To: **South Tyneside Council**  
From: **Iceni Projects Ltd (Transportation)**  
Date: **12<sup>th</sup> February 2016**  
Title: **ST/0955/15/FUL - Former Be Modern Premises, Western Approach, South Shields**

**b. Response to STC Comments**

**A1. PROPOSED TURNING HEADS**

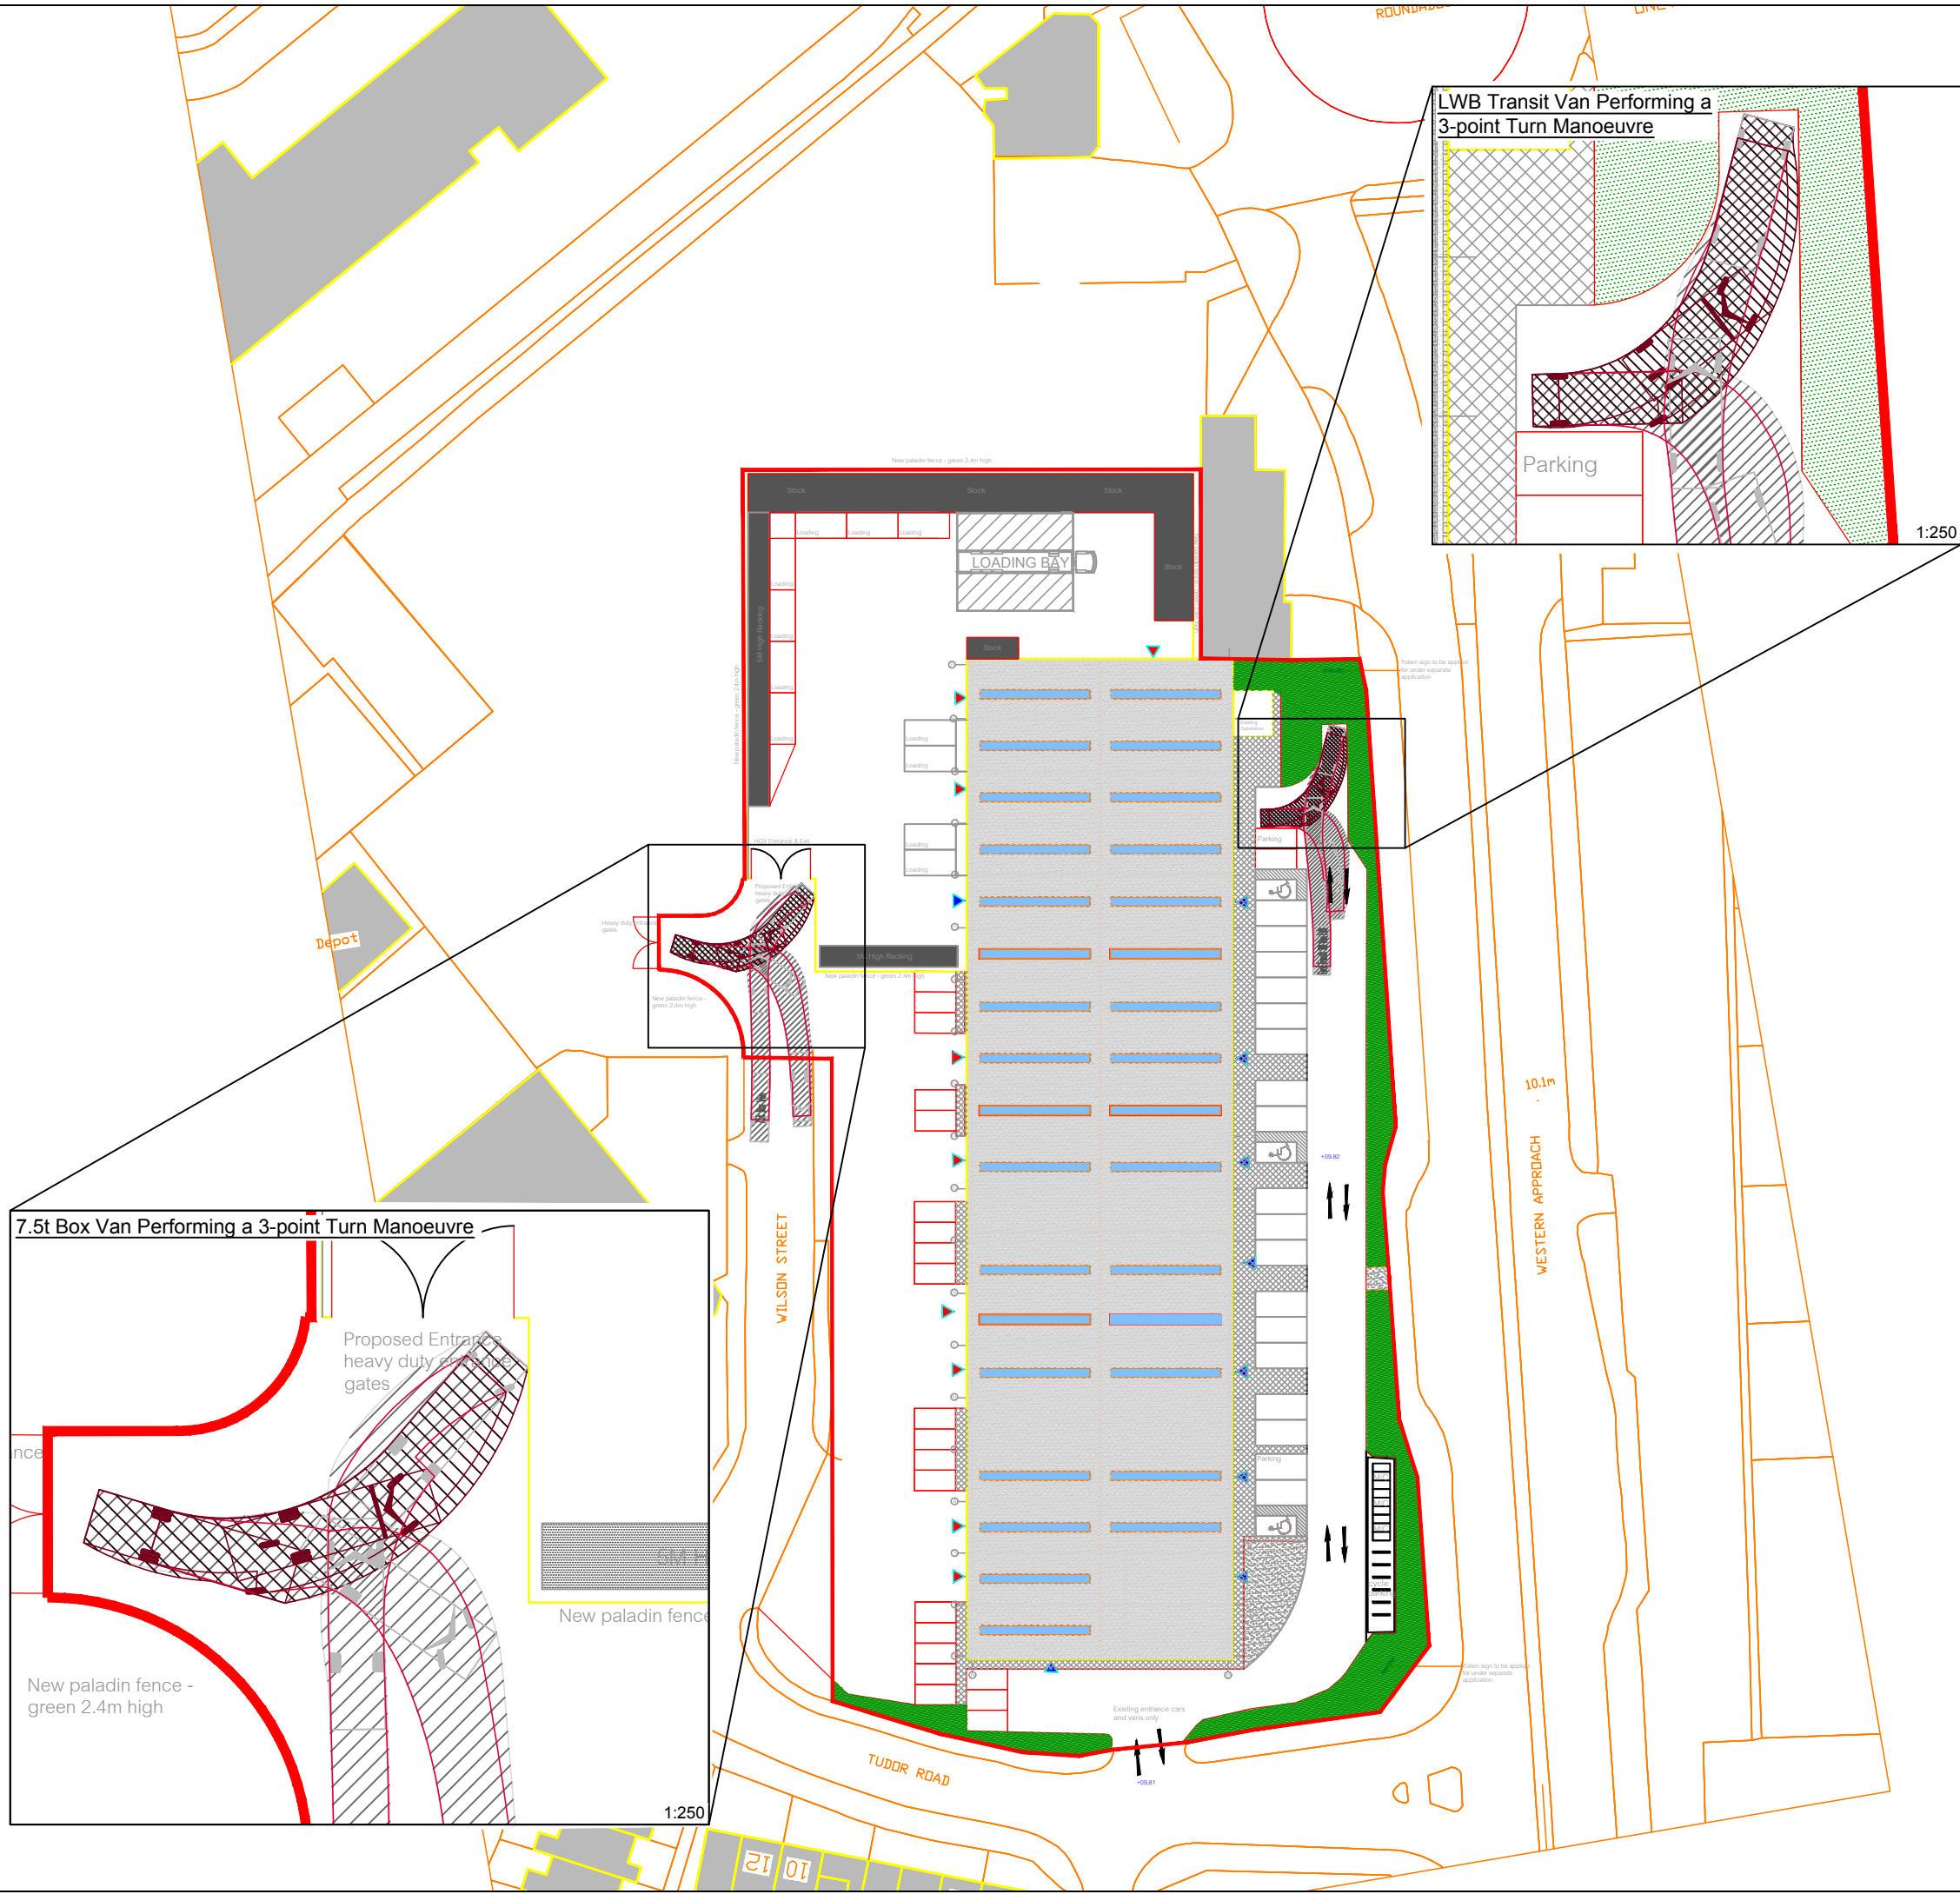
16. *There is no turning head provided for the customer car parking area, this should be created and could lead to a loss of car parking spaces.*
17. A tracking drawing showing the space needed for a long wheel based transit (largest typical trade customer vehicle) to turn to the north of the customer car park should they drive to the end of the car park is shown at Appendix A1. While a turning head could be accommodated in this area, it will impact on existing and proposed landscaping including a TPO tree so it has been necessary to remove two spaces. The likelihood of a large vehicle driving to the end of the car park and not being able to reverse a short distance to utilise the parking area to turn around is low as they will be able to see there are no van spaces at that end of the car park and also that there is insufficient space within which for them to turn. In addition to the turning head, signage will be provide

27. It is considered that a turning head is not essential as it will be seldom used and is more likely to be used as parking by staff of the existing and proposed units once it becomes known that it is not used. Notwithstanding this, consideration has been given to whether a turning head could be provided to enable a long wheel based transit to turn, as this is the largest typical vehicle used by trade customers. A drawing showing this is included at Appendix A1.

**A3. SERVICE VEHICLE TRACKING**

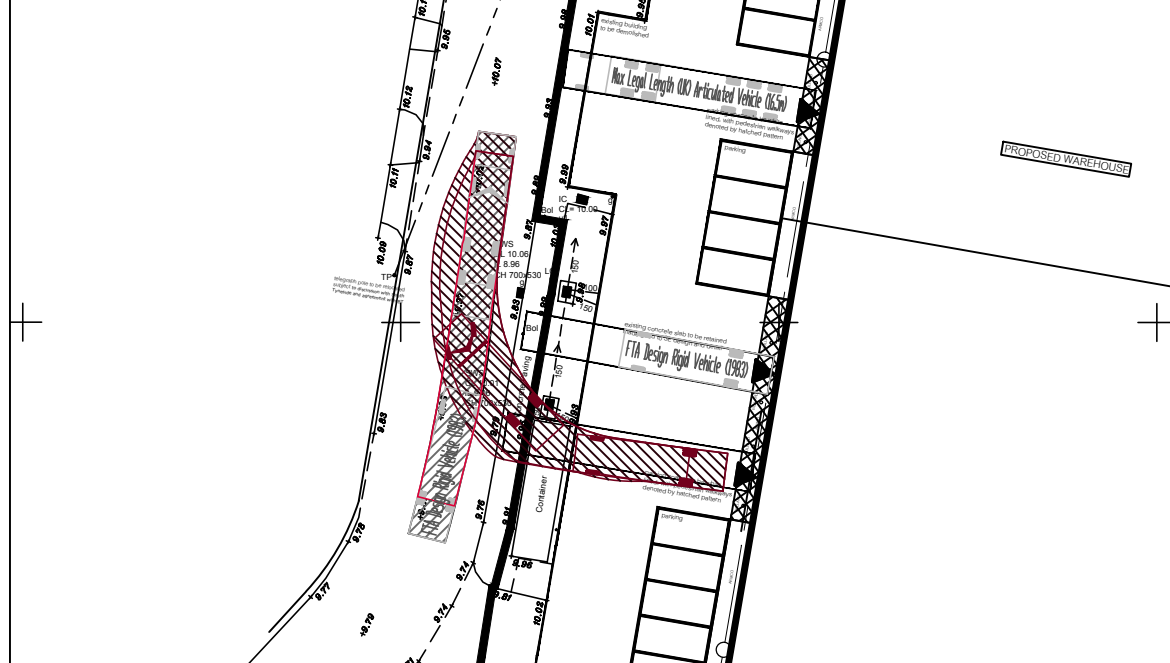
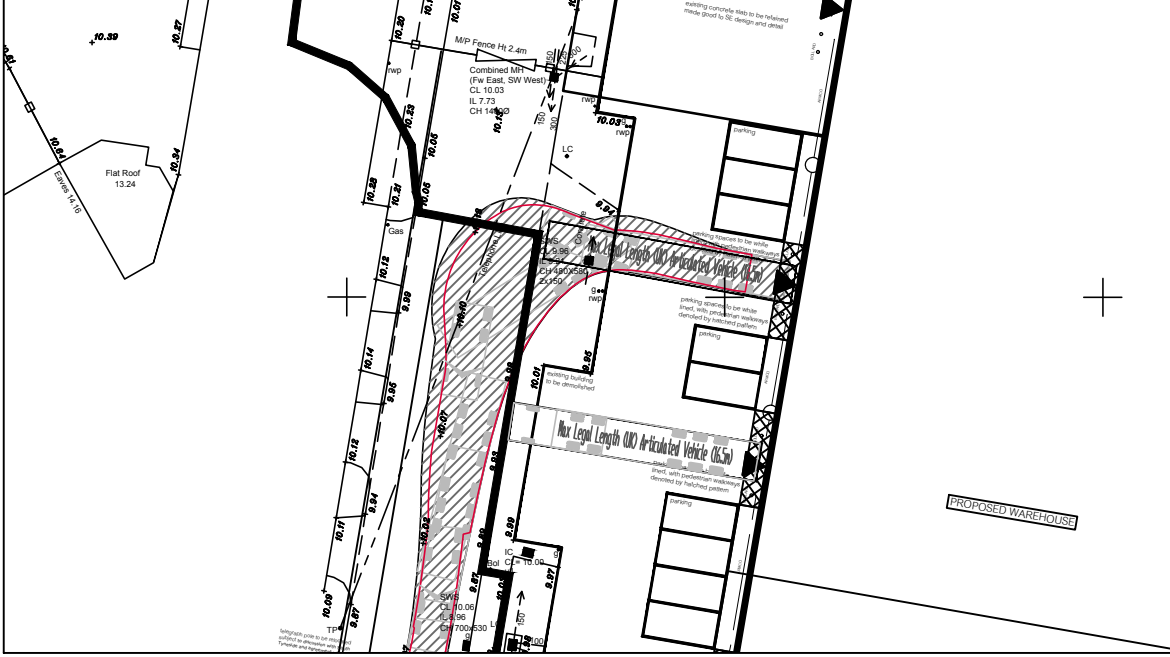
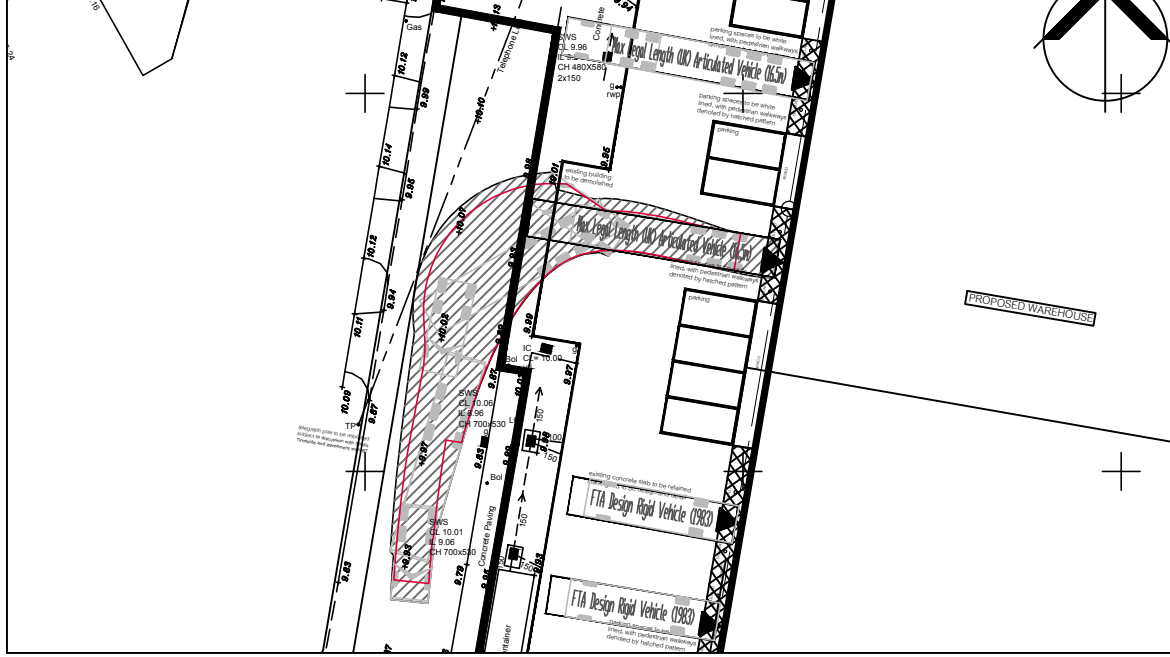
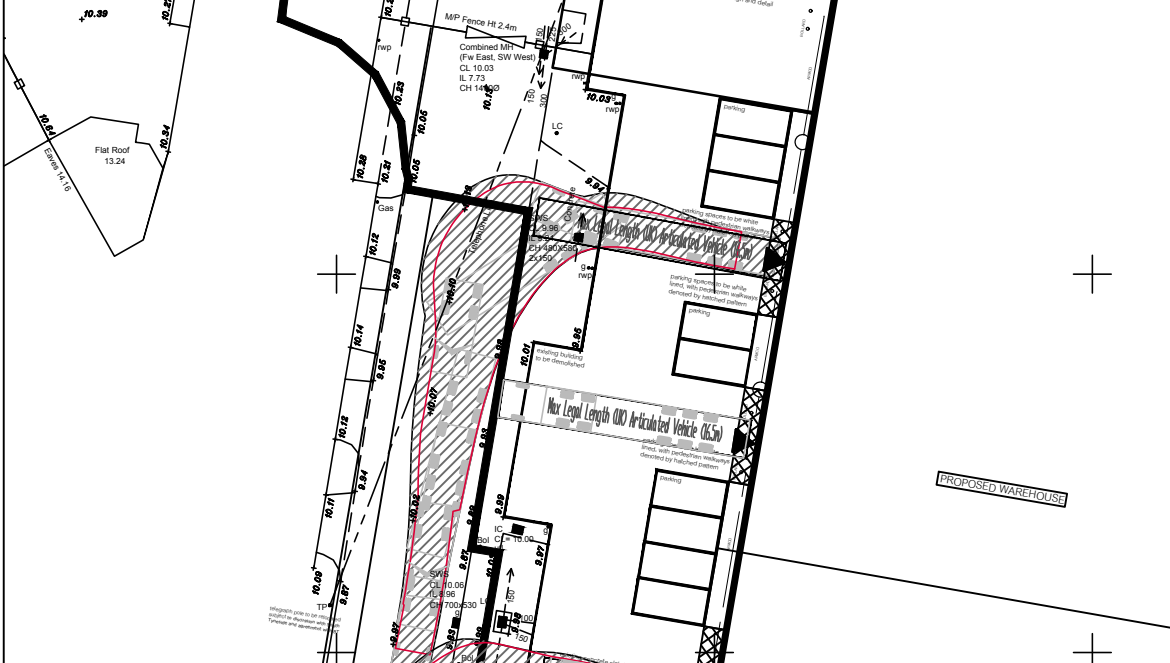
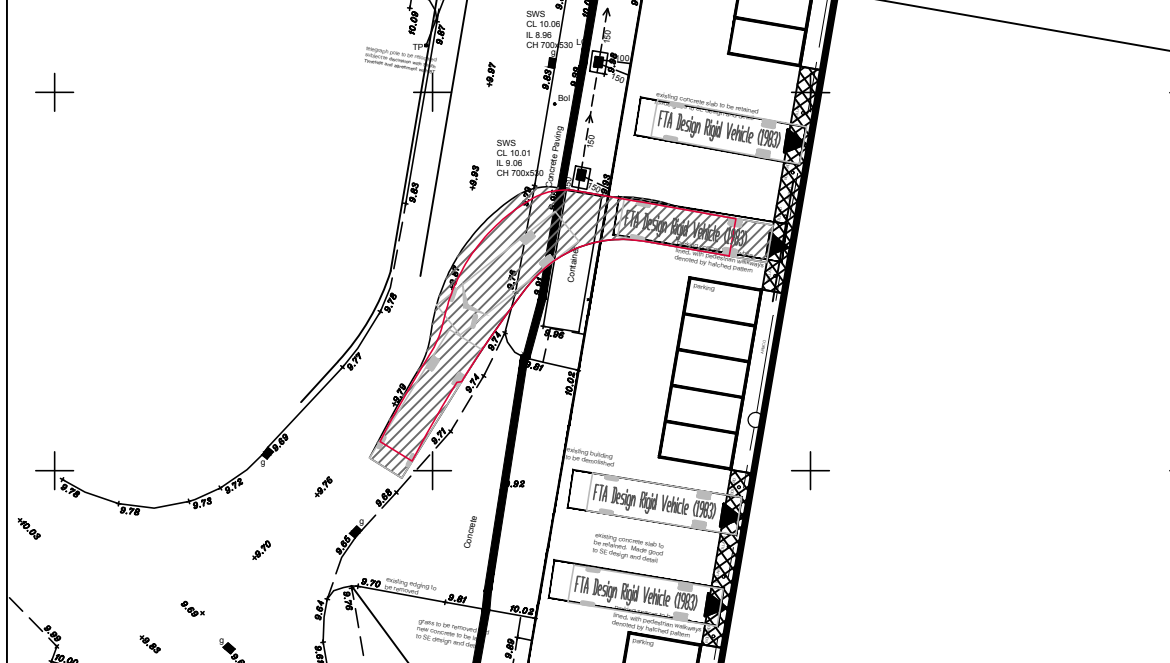
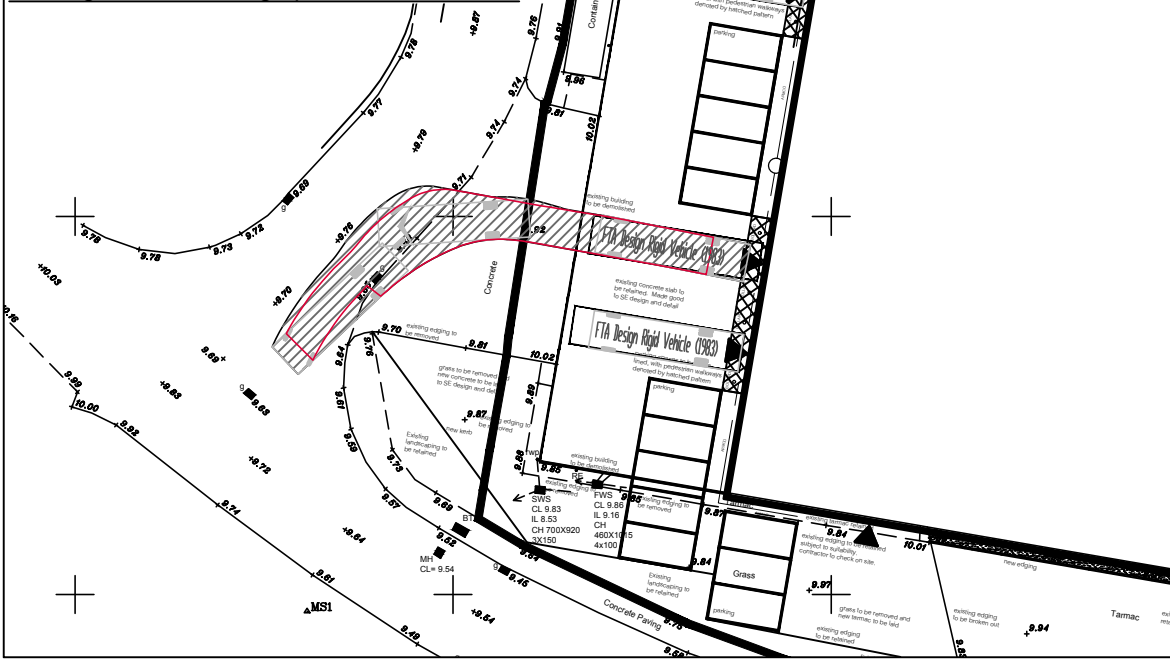
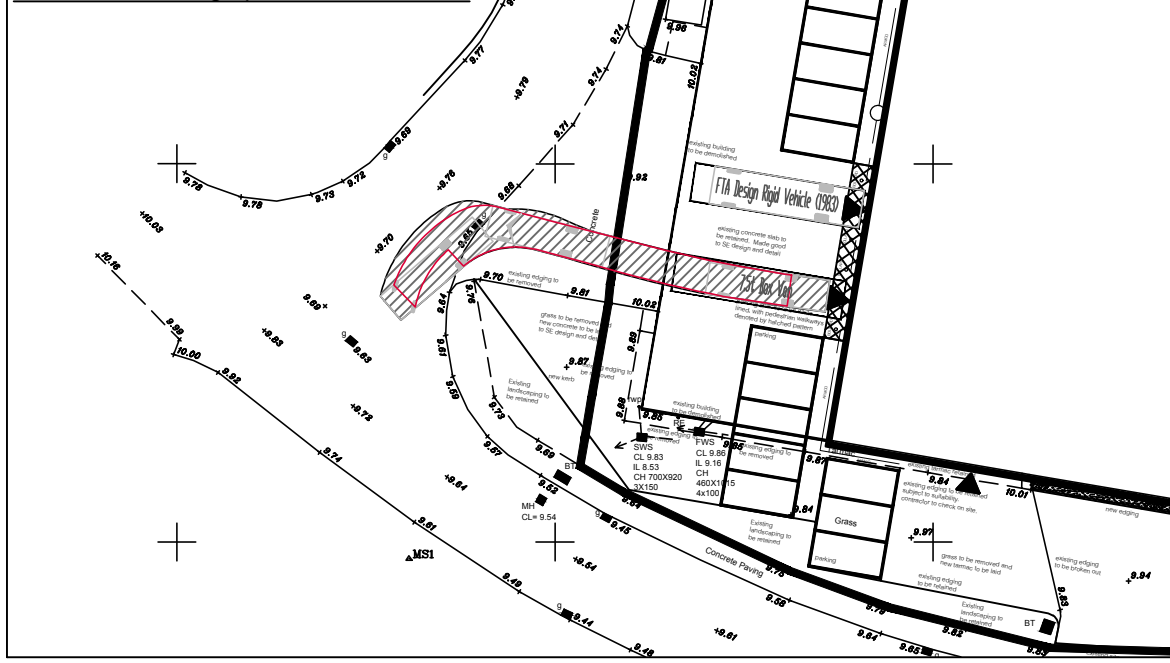
34. *The vehicle tracking information will also need to show the existing adopted highway and also show whether or not the HGVs will need to use the existing adopted highway whilst parked during servicing.*

35. *May I advise that there are concerns about the servicing arrangements off Wilson Street, however detailed comments and conclusions from the Council's Highway Engineers cannot be made, until all of the above further information is provided.*

36. The building has been sited so that 16.5m articulated lorries can wait off the carriageway. There is no formal footway along the eastern side of Wilson Street at present and no footway will be provided as part of the proposal. Any pedestrians wishing to walk along Wilson Street can do so via the footway on the western side, however, no pedestrians will need to walk to the development site along this road as all units are accessed from the front via the car park area and any pedestrians visiting the existing units on the western side of Wilson Street will walk on the western side in any case. Any future development to the north west could also be accessed via the western footway.

37. In order to demonstrate that the carriageway will not be impeded, a set of drawings are included at Appendix A3 showing the location of vehicles parked at each of the loading doors. On this basis there should be no pedestrians or vehicles affected by vehicles servicing the site apart from up to 10 times per day in total when vehicles may be reversing back to the loading doors. As stated previously, this is very much a worst case as generally there will be fewer than this.
